ATTACHMENT 5

Letter from M. E. Warner (NMC)

License Amendment Request 187

Revised Pages for Updated Safety Analysis Report
(USAR)

Figure 14.1.6-6

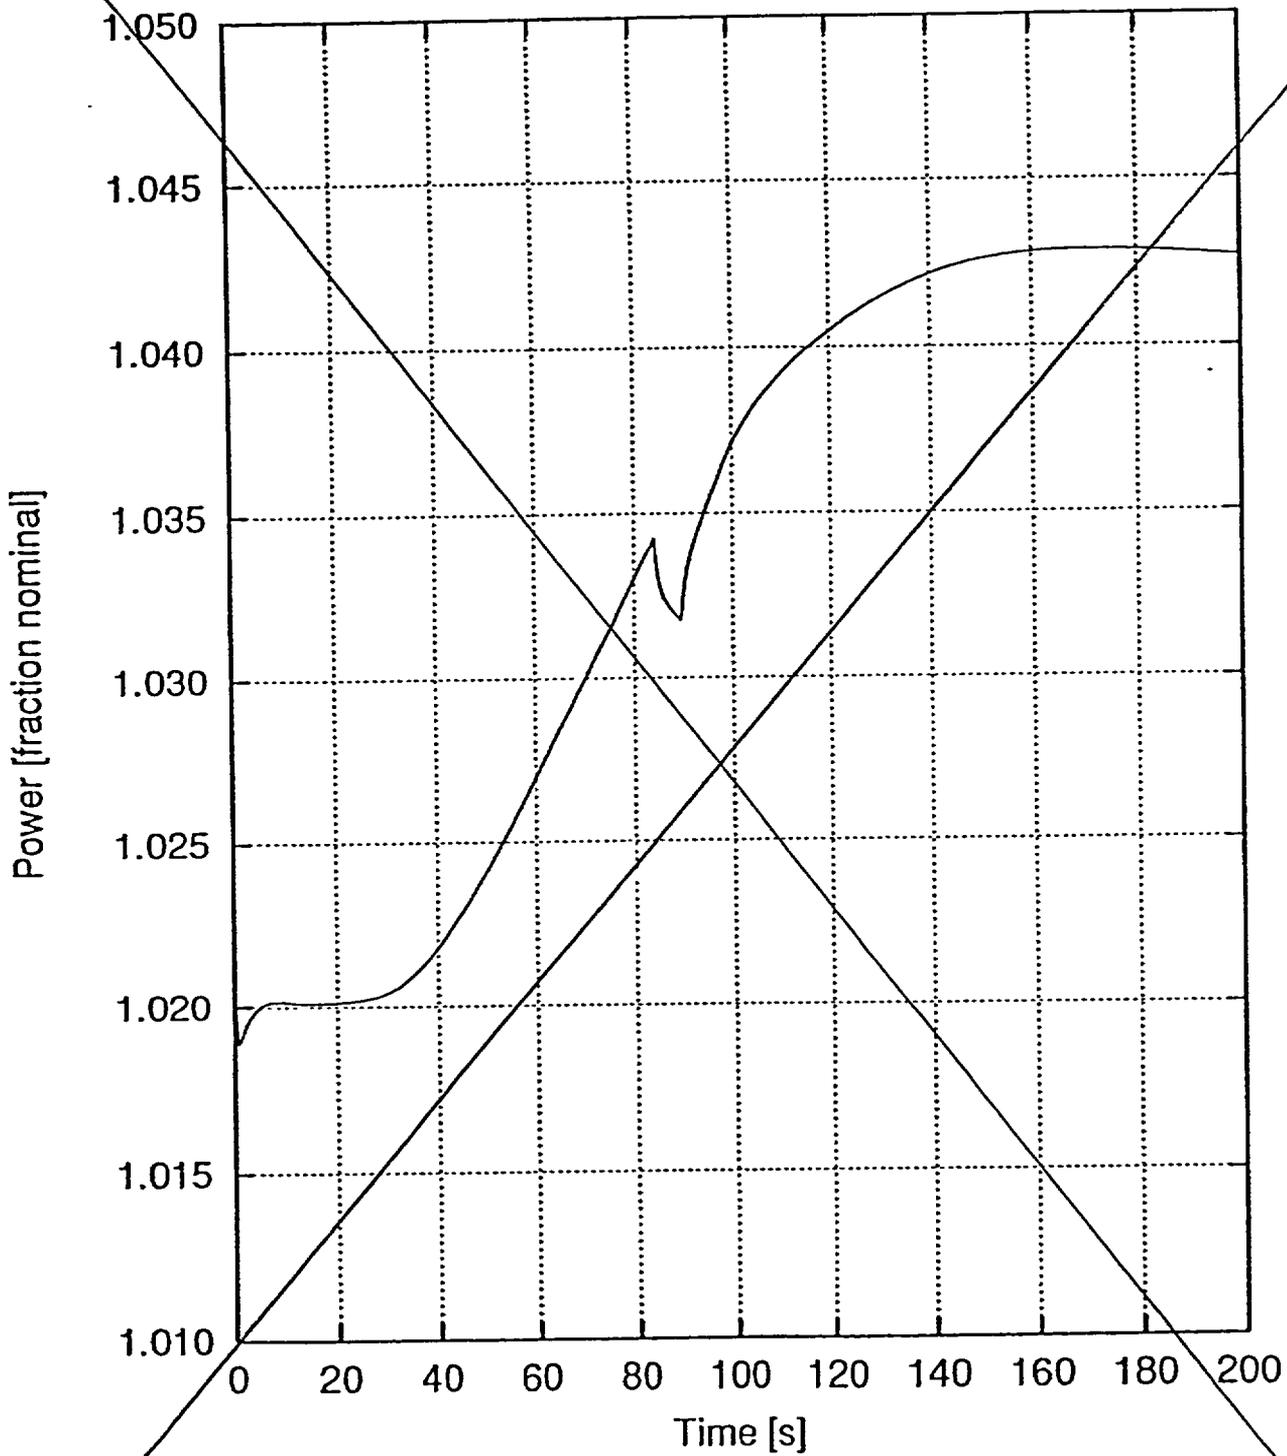
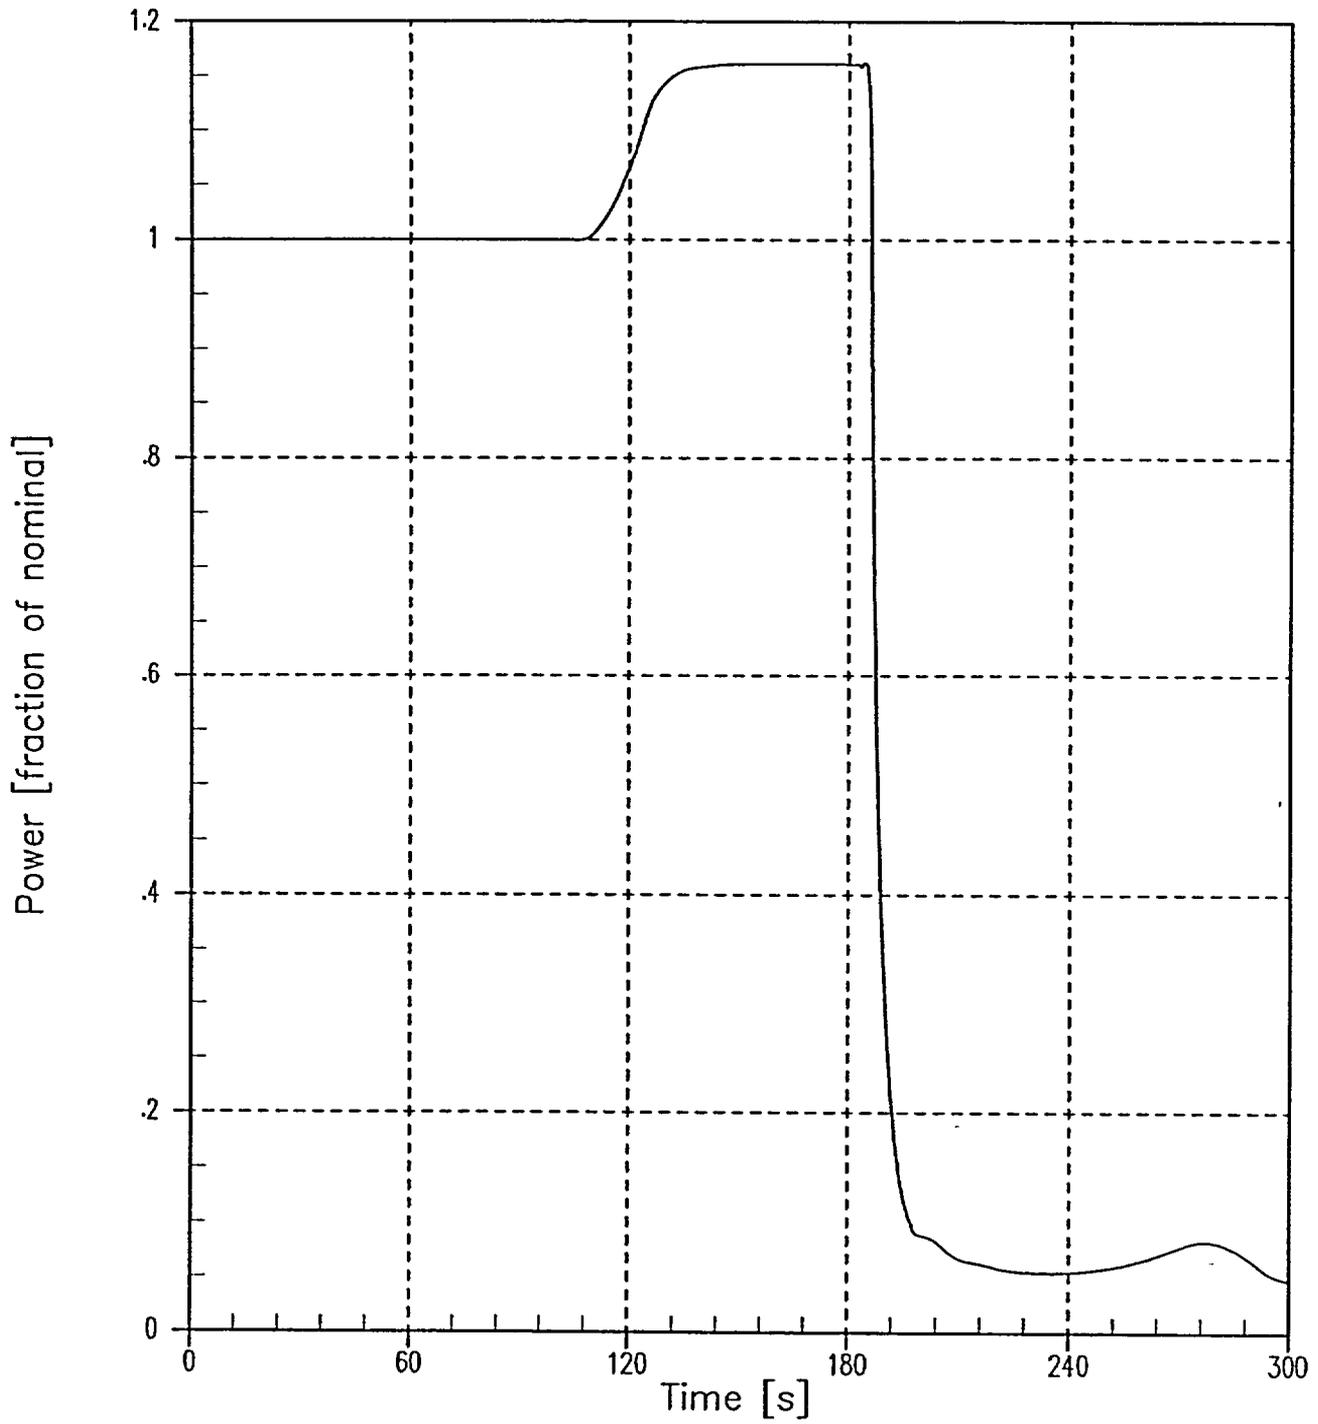
REPLACE WITH FIGURE 14.1.6-6 (ON FOLLOWING PAGE)

Figure 14.1.6-7

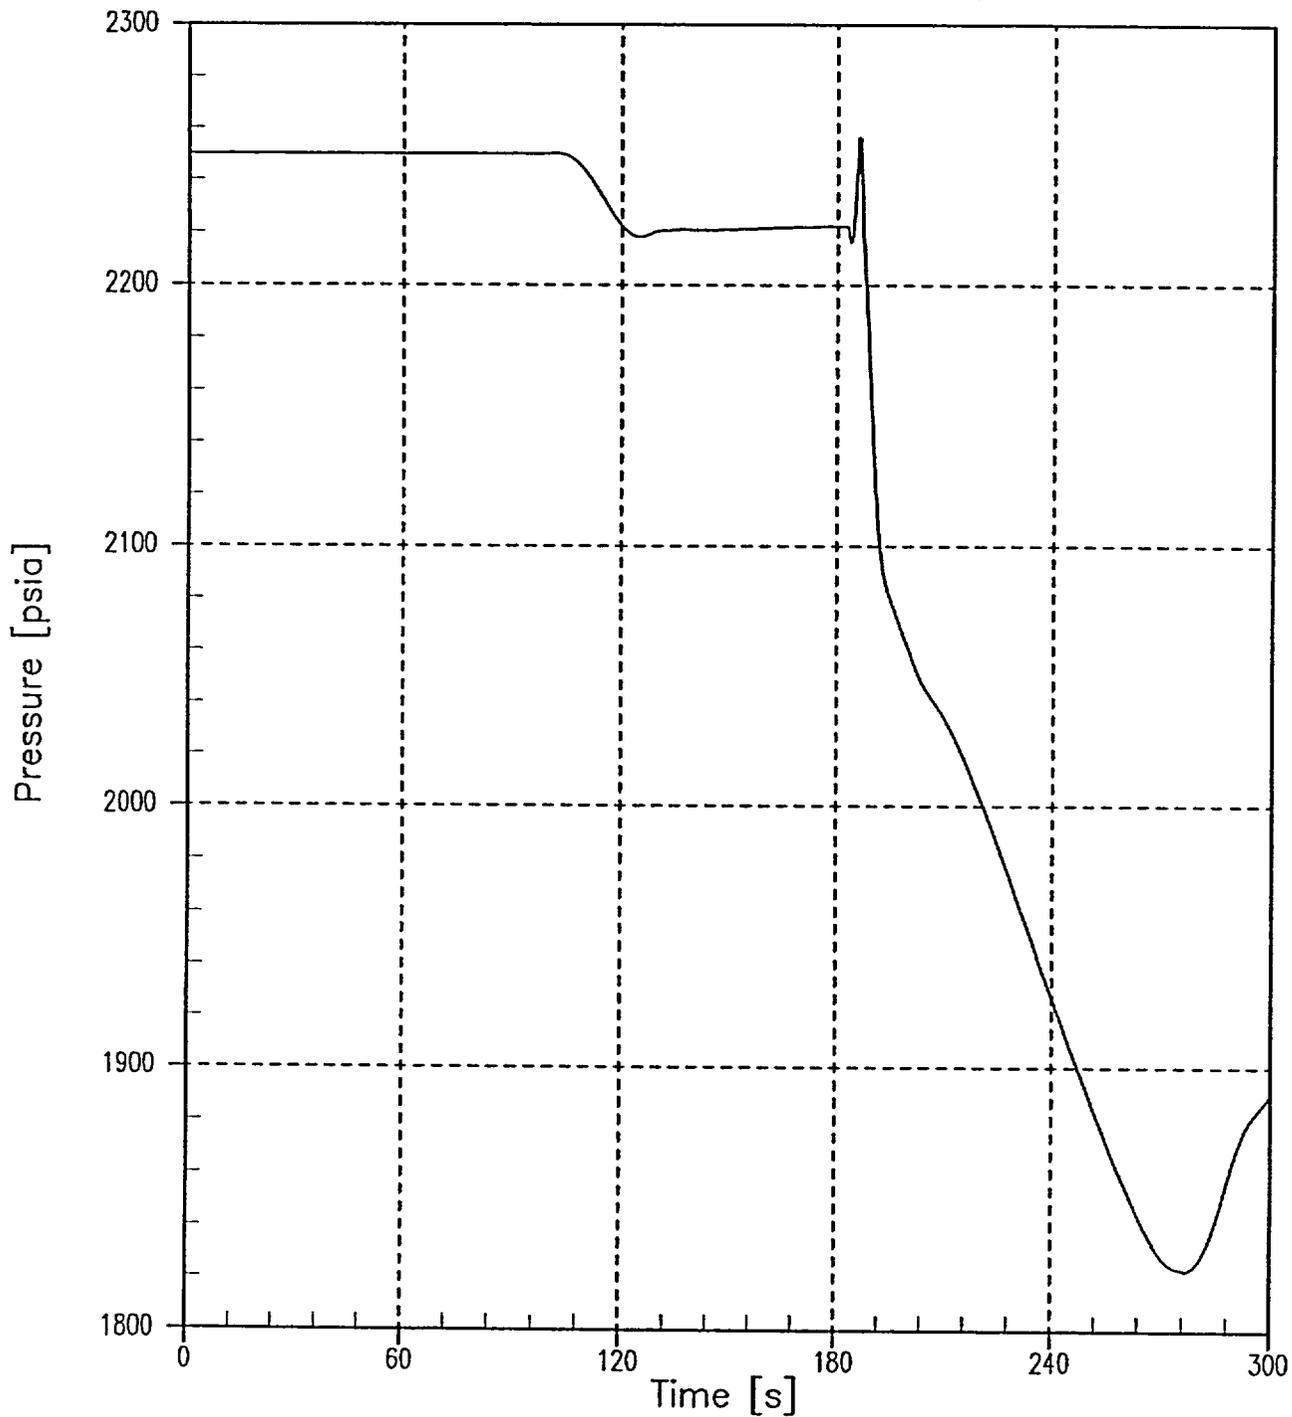
REPLACE WITH FIGURE 14.1.6-7 (ON FOLLOWING PAGE)

Figure 14.1.6-8

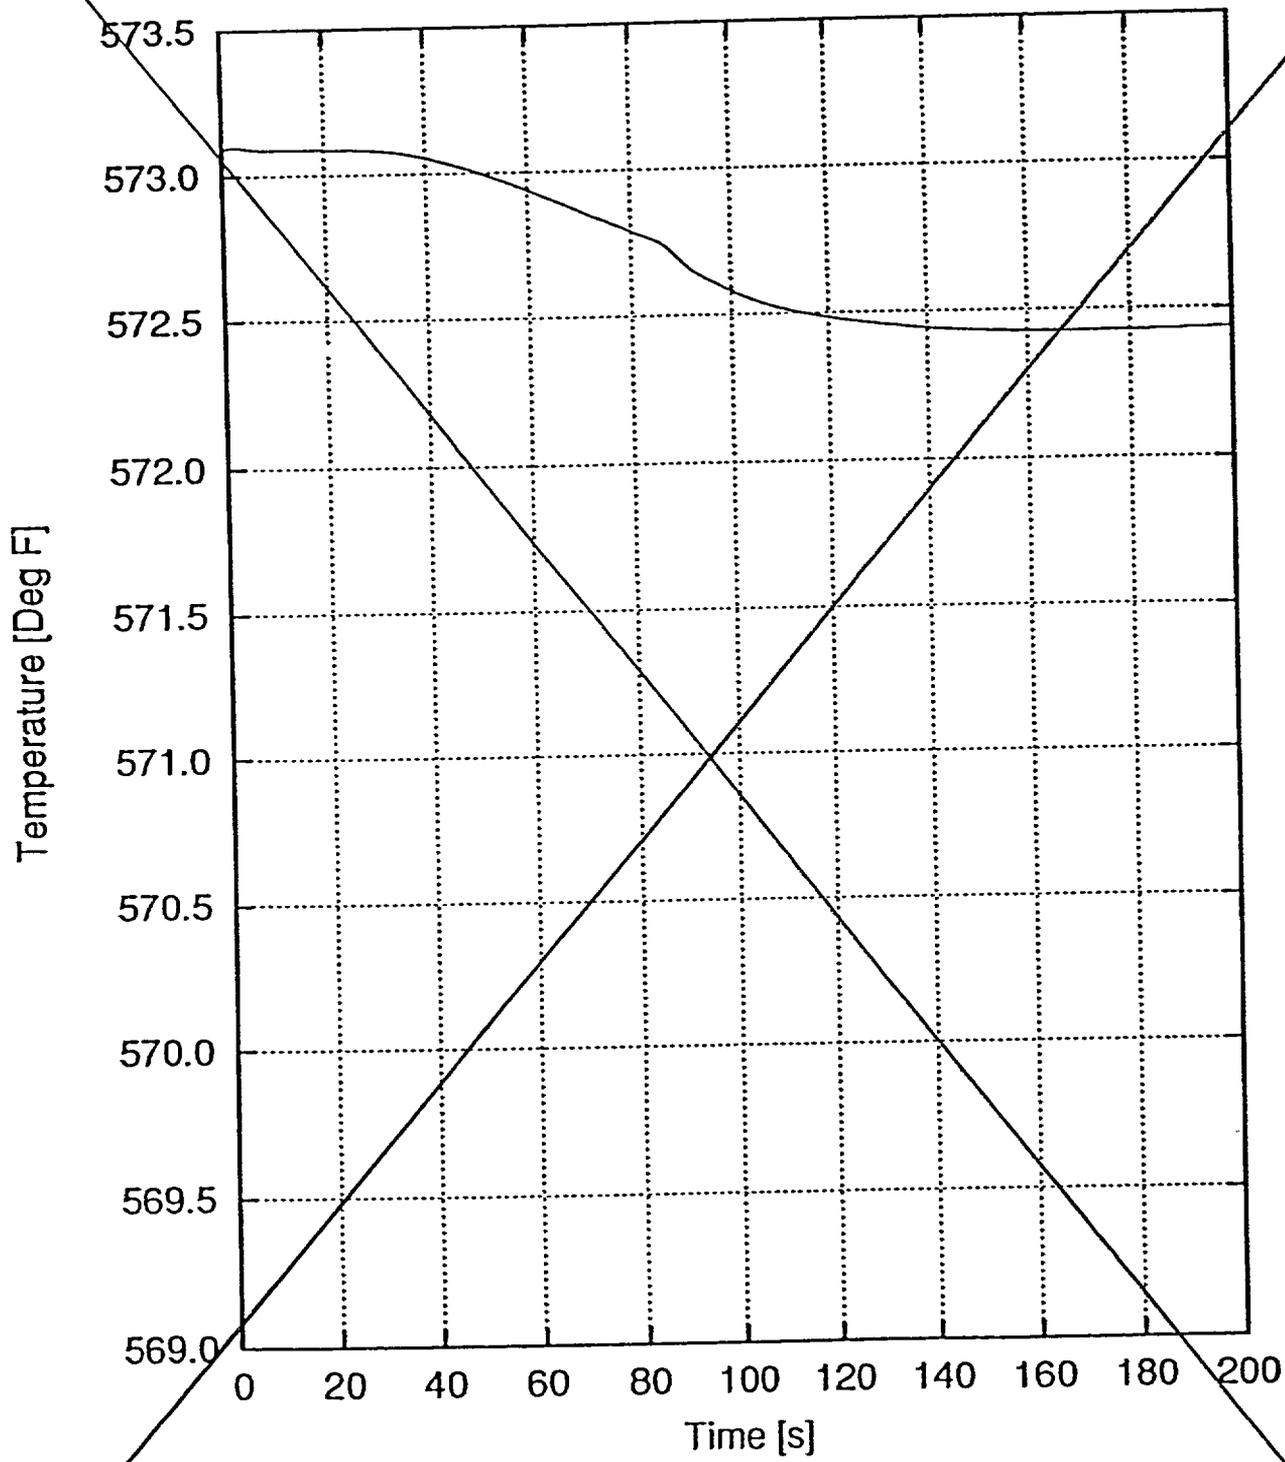
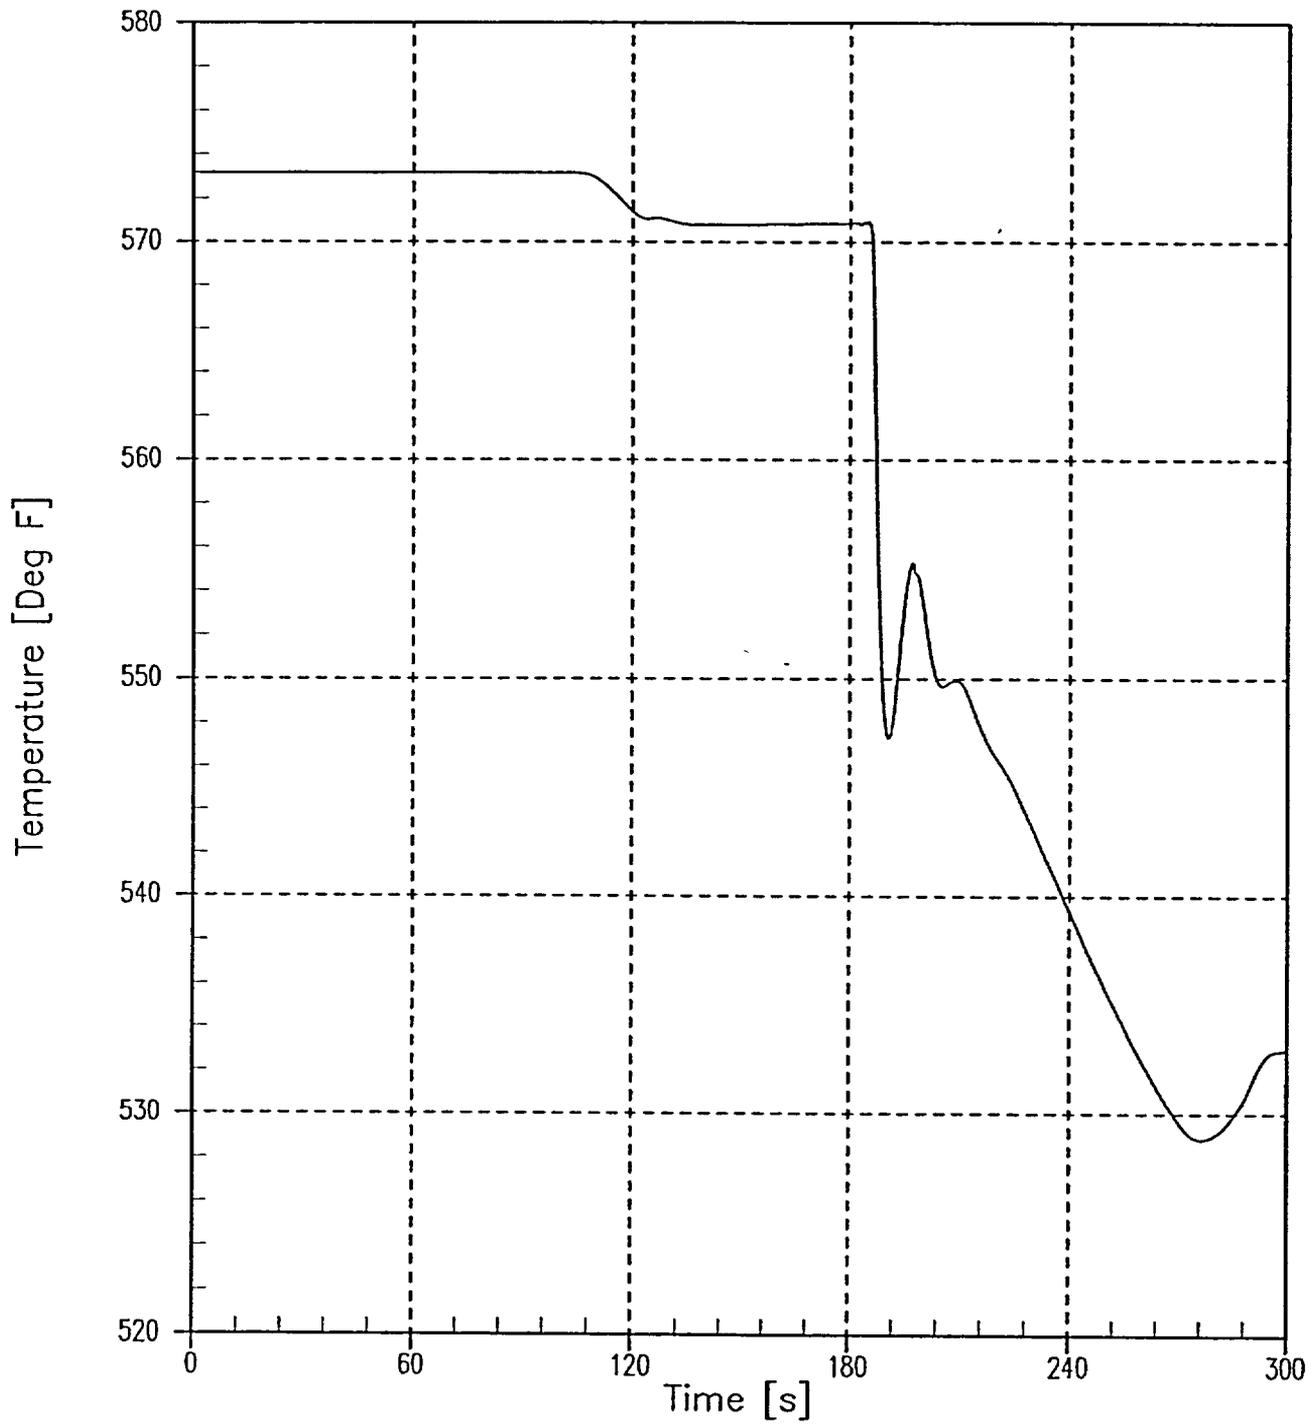
REPLACE WITH FIGURE 14.1.6-8 (ON FOLLOWING PAGE)
